REGULATION No. 48
(Installation of lighting and light-signalling devices)

Clarifications on installation requirements

Proposal for draft Supplement 5 to the 04 series of amendments to Regulation No. 48

Submitted by the expert from Germany */

Figure 1

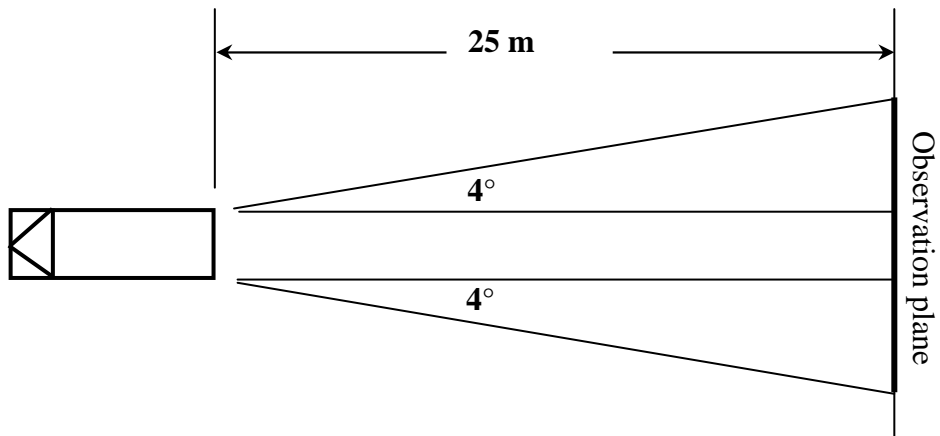
6.21.5.1. for rear conspicuity markings (see Annex 11, Figure 1) the observation plane is perpendicular to the longitudinal axis of the vehicle situated **25 m** from the extreme end of the vehicle and bounded by:

- 6.21.5.1.1. in height, by two horizontal planes 1 m and 3.0 m respectively above the ground,
- 6.21.5.1.2. in width, by two vertical planes which form an angle of 4° outwards from the vehicle's median longitudinal plane and which pass through the intersection of the vertical planes parallel to the vehicle's median longitudinal plane delimiting the vehicle's overall width, and the plane perpendicular to the longitudinal axis of the vehicle that delimits the end of the vehicle.

Annex 11, amend to read:

Figure 2

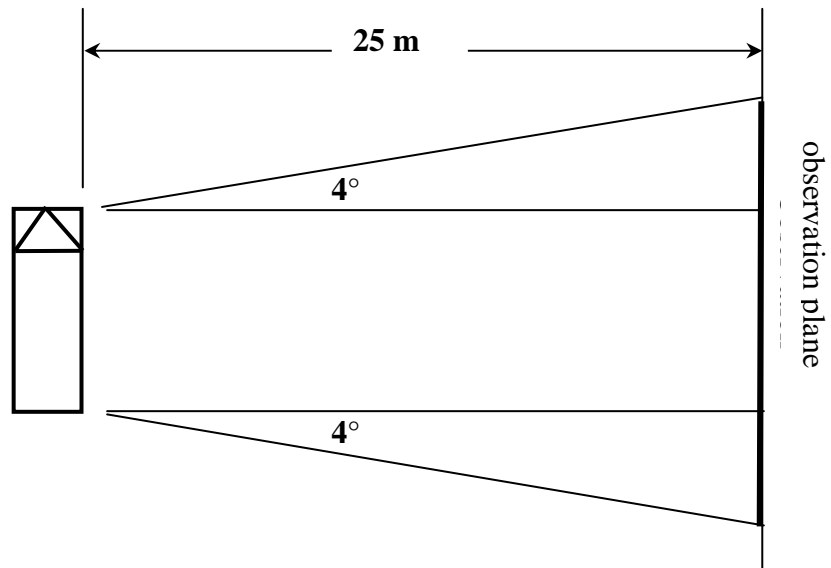
- 6.21.5.2. for side conspicuity markings (see Annex 11, figure 2) the observation plane is parallel to the longitudinal median plane of the vehicles situated **25 m** from the extreme outer edge of the vehicle and bounded by:

- 6.21.5.2.1. in height, by two horizontal planes **1.0 m** and **1.5 m** respectively above the ground,
- 6.21.5.2.2. in width, by two vertical planes which form an angle of 4° outwards from a plane perpendicular to the vehicle's longitudinal axis and which pass through the intersection of the vertical planes perpendicular to the vehicle's longitudinal axis delimiting the vehicle's overall length and the extreme outer edge of the vehicle."
